Determination 2015/053

Regarding the refusal to issue a building consent in respect of barriers to a swimming pool at 26 Sunrise Valley Road, Upper Moutere

Figure 1: Site plan showing existing structures & location of pool and barrier (Not to scale)

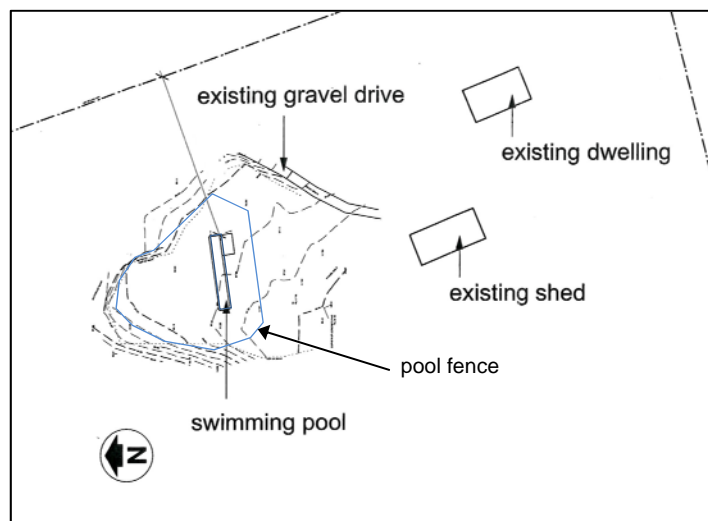
- 2.2.4 The pool barrier is formed by two different types of fencing, described as "Timber Fence Type 1" and "Windbreak Fence Type 2" in the consent application. The timber fencing is used for the majority of the barrier and is constructed from wooden posts with wooden rails, and vertical palings, and measures at least 1.2m high. The consented plans show that there are two self-closing and latching pool gates set in this part of the fence.

- 2.2.5 The windbreak fencing, Type 2, was erected along the pool enclosure's southern side, and is formed from metal posts at 3m intervals, with tensioned wires running between their tops and bottoms. The bottom wire is fixed to the ground. A windbreak fabric is secured between the two wires to form the body of the fence. In the consented drawing this is described as 'high-quality windbreak mesh securely fixed to top and bottom wire'. From the photos it appears to be green open weave windbreak fabric, of the type commonly used in orchards. The section of the barrier formed from this second type of fencing measures approximately 28m long. It also stands 1.2m high.

- 2.2.6 The area enclosed by the pool barrier is roughly an oval, except along its northern side, where the barrier forms a straight edge. It appears that this area is the same as that shown on the consented plans. The parties estimate that the area enclosed by the barrier is between 800 sq. m and 1000 sq. m. There is a large level area immediately around the pool, and the land slopes down towards the west and the north with the fence placed at the base of slope so as to make it not visible from the pool area. There are substantial plantings around the fence, particularly on the west side.

- 5.5.1 Although it did not form part of the current determination, I have some reservations as to whether the consented pool barrier, as it is currently constructed, would comply with Clause F4 in other respects, due to the nature of the materials used to construct the windbreak fence (see paragraph 2.2.5).
- 5.5.2 The parties disagree as to whether this section of the pool fence was meant to be temporary or not; it was not clear on the plans provided for the construction of the fence that the windbreak fence was a temporary measure and a dwelling was planned. However, given the differences in the types of fencing constructed it would have been reasonable for the authority to raise that question. Irrespective of its intended permanence, the barrier must still comply with Clause F4.3.4, which

6.3 I suggest that the parties liaise to agree on the area that would be appropriately encompassed by the barrier, taking into account my comments in this determination and the rural nature of the owners' property. The owners should then then apply for an amendment to building consent 130961 to reflect the compliant design and the intended location of the dwelling in order that a code compliance certificate be issued.

Figure 2: Site plan of proposed dwelling and the existing pool (Not to scale)

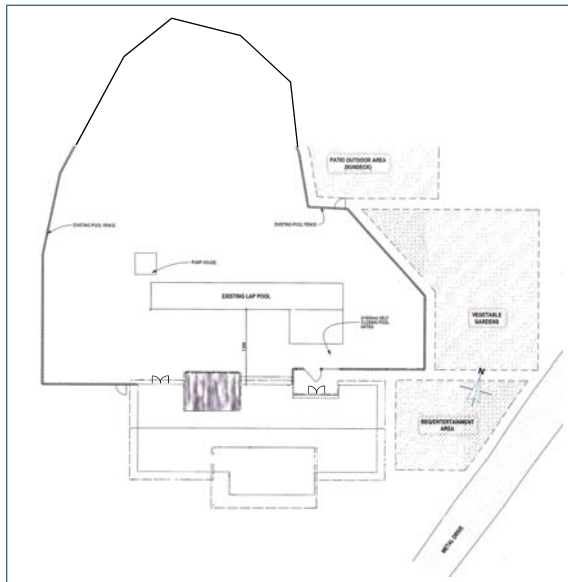
- 2.3.2 The final plans submitted for the proposed building work show a single-level north-facing dwelling, with the existing pool fence extended and altered so that it meets up with the dwelling on its north-western corner. On the other side of the dwelling the fence would be brought in front of the dwelling, and join the wall on the eastern side of the living room doors. A self-closing pool gate would sit in the barrier at this point, in front of the living room doors. (See figure 2 over page)

- 2.3.3 The remainder of the pool barrier on the Northern side of the house would be formed from the house walls. There are two sets of double-doors and several windows within this section of the wall. One set of doors leads out from the master bedroom; the other from a living area designated on the plan as a weaving room. The plans show that the doors would be fitted with self-closing mechanisms and raised handles set at 1.5m above ground. The owners advise they would also be self-latching. The four windows in this section of the wall, which are capable of being opened, are shown on the plans to be fitted with restrictor stays.

- 5.3.4 The doors are shown on the plans as self-closing, and the owners assert they will also be self-latching. They are to be fitted with door handles at 1.5m of height to make them difficult for small children to operate. The doors are not sliding doors, and so do not come within the exemption in Clause F4.3.5.

- 5.4.13 I note that in this case the area enclosed by the barrier is on the north side of the house. The living spaces and doors all opening out to the north with just the entrance on the south elevation. The area is significant in terms of its physical size, its location immediately adjacent to the house, and also in that it contains a large flat area.

- 5.4.15 I acknowledge that the owners have elected to have the BBQ, vegetable garden, and sunbathing area outside the barrier. However I consider that the physical size, (which the parties place at between 800 sq. m and 1000 sq. m) and the distance at its furthest of the barrier from the perimeter of the pool, along with the relationship to the site and the dwelling, and the activities likely to occur within the proposed enclosed area mean that the ‘close nexus’ test as set out in the *Hickman* decision and subsequent determinations is not being met. In addition the land at north and west perimeter slopes downhill, such that an adult may be present in those areas and not be aware of a child present in the pool or in close proximity to the pool.

5.6.1 I conclude that the section of the proposed pool barrier that incorporates two sets of doors and four opening windows, as shown on the plans submitted for the second building consent, complies with Clause F4 of the Building Code. However, given the area enclosed by the barrier, the location with respect to the dwelling and the remaining property, and the activities likely to occur on the large flat area, I conclude the barrier does not comply with the requirement in Clause F4.3.4 to restrict the access of children under 6 years of age to the immediate pool area.

- the area enclosed within the pool barrier does not comply with Clause F4 of the Building Code in respect of the immediate pool area
- as the proposed pool barrier does not comply in respect of the immediate pool area, I consider the authority correctly exercised its powers of decision in refusing to issue a building consent, and I confirm that decision.
